CITY OF FRANKLIN
REPORT TO THE PLAN COMMISSION

Meeting of September 7, 2017

Comprehensive Master Plan Amendment, Special Use and Certified Survey Map

Project Name:	Zilber Apartments
General Project Location:	7333 South 27 th Street
Property Owner:	Metropolitan Milwaukee YMCA Bank Creditor Trust
Applicant:	Zilber Ltd.
Agent:	Mike King, Zilber Ltd.
Current Zoning:	B-4 South 27th Street Mixed Use Commercial District
2025 Comprehensive Plan:	Mixed Use
Use of Surrounding Properties:	Single-family residential to the north, Platt Construction, Inc. and vacant land to the south, City of Oak Creek to the east and vacant land (zoned B-4 District) to the west
Applicant's Action Requested:	Approval of applications related to the proposed multi-family residential development

DATE:	AUGUST 24, 2017
JOB NUMBER:	70000
DESCRIPTION:	WETLAND DISTURBANCE PROTECTION PLAN
SHEET:	EX. 1

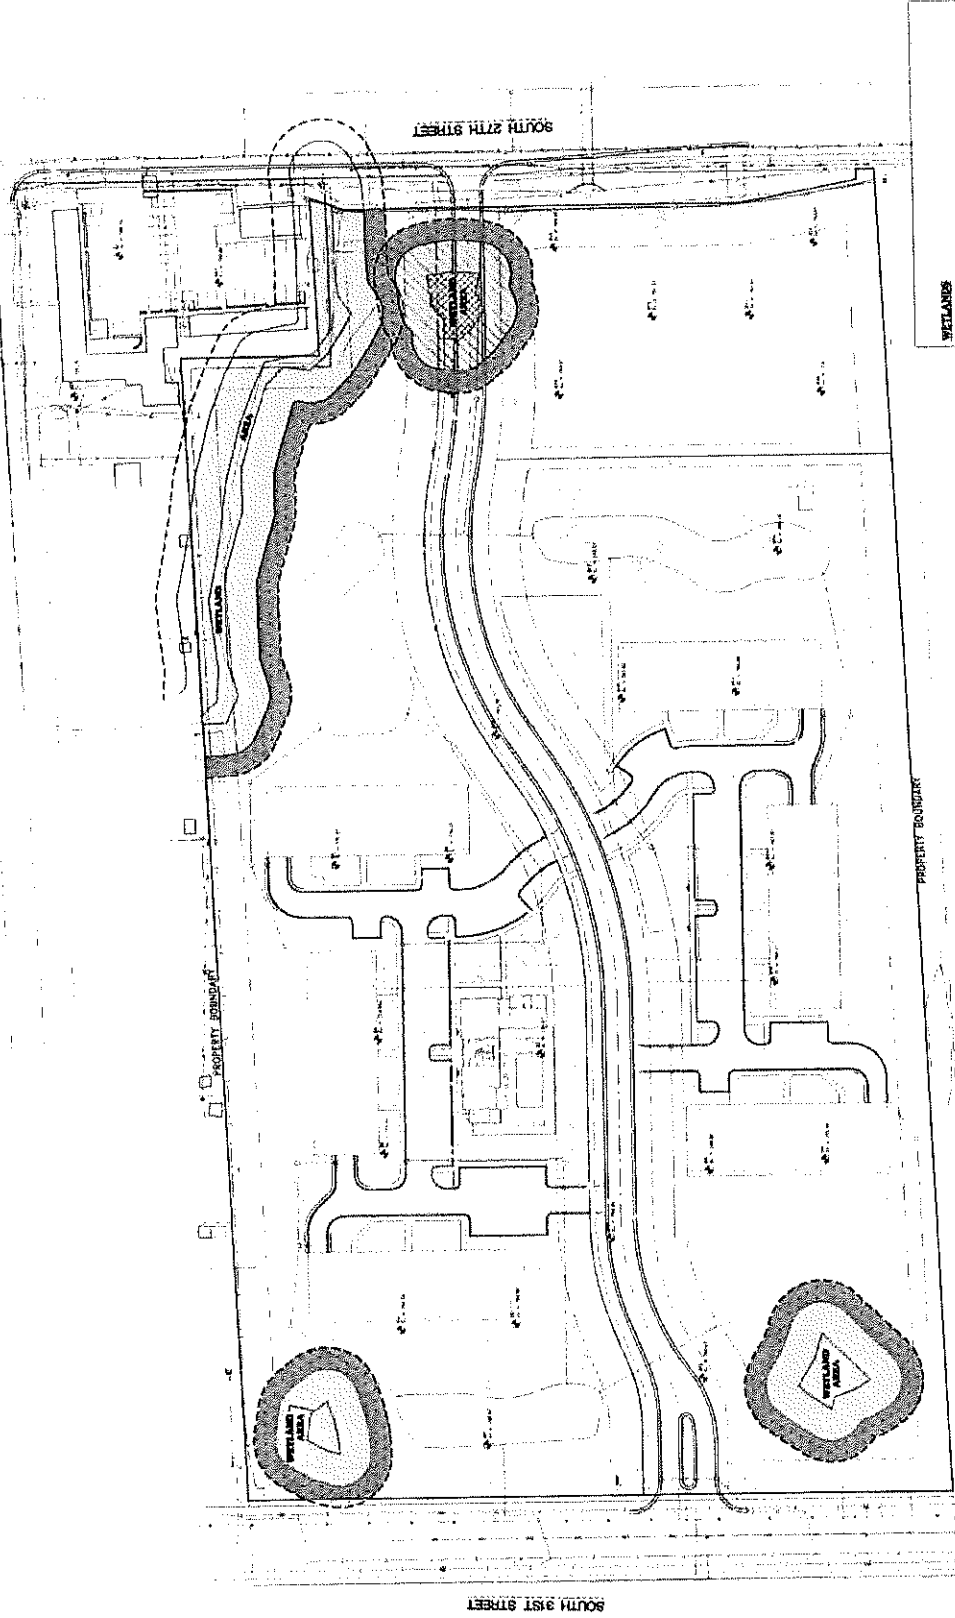
The applicant has illustrated the conservation easement boundary on Sheet EX.1, which includes protection of the wetland and wetland buffer for the two wetlands adjacent to S. 31st Street, but not for a third wetland adjacent to S. 27th Street. Therefore, staff recommends that the applicant shall revise the Conservation Easement to include protection of the wetland and 30-foot wetland buffer for all three remaining wetland areas onsite. Sheet EX.1, the Site Development Plan (Sheet C300) and the Certified Survey Map shall all be revised to illustrate the boundary as such and be labeled accordingly. In addition, staff suggests that the conservation easement also include the 50-foot wetland setback.

The applicant has provided an exhibit (Sheet EX.1) illustrating these impacts as well as an alternative analysis. These impacts may be allowed by the Common Council per Ordinance No. 2016-2224, which states that all public streets, sidewalks and trails construction shall not be subject to the natural resource features protection standards following review and approval by the Common Council. However, the applicant did not address sections i), ii), and iii) of

9. The applicant shall revise the Conservation Easement to include protection of the wetland and 30-foot wetland buffer for all three remaining wetland areas onsite, with the northeasterly area conservation easement to include specific provisions to allow for the use of the area in furtherance of the development of the adjoining parcel, access thereto and drainage. Sheet EX.1, the Site Development Plan (Sheet C300) and the Certified Survey Map shall all be revised to illustrate the boundary as such and be labeled accordingly.

12. The applicant shall revise the practicable alternatives analysis to address sections (f i), ii), and iii). for review and approval by the Common Council prior to issuance of a Building Permit.
13. The applicant shall enter into a Development Agreement with the City of Franklin, prior to the issuance of a Building Permit.

SHEET:
OVERALL SITE LANDSCAPE PLAN

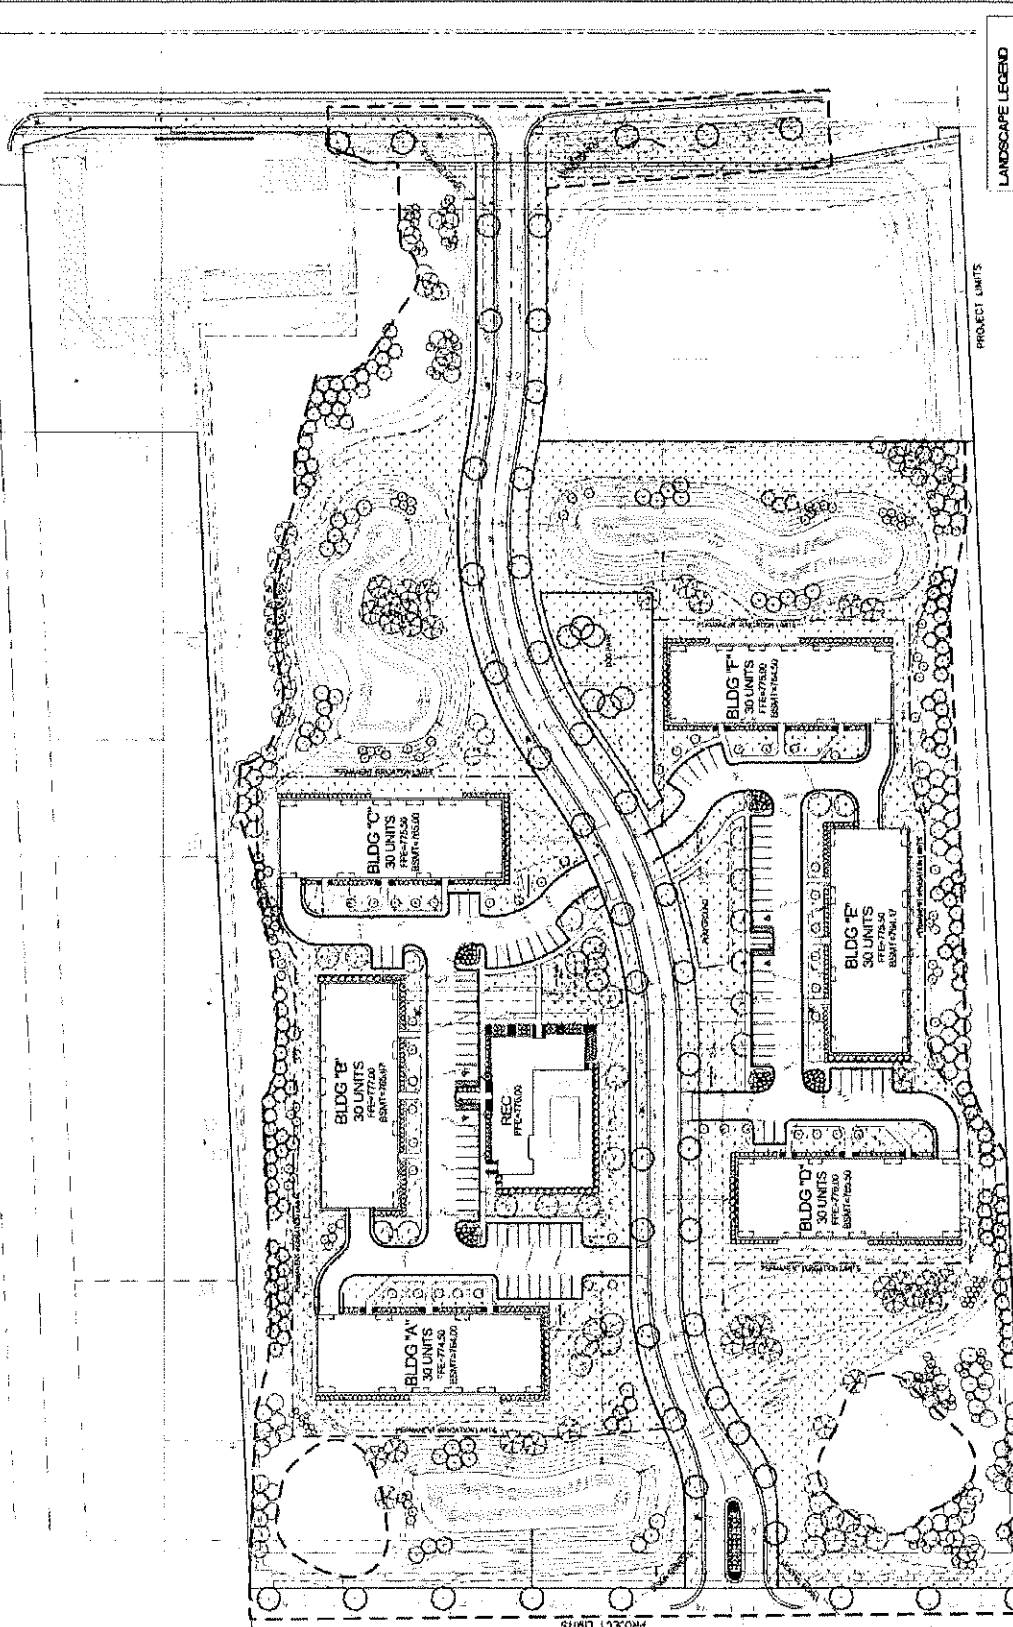
29. Please illustrate areas for snow storage on the Landscape Plan, Sheet L100, in compliance with Section 15-5.0210 of the UDO.

Snow storage areas have been designated on sheet L100.
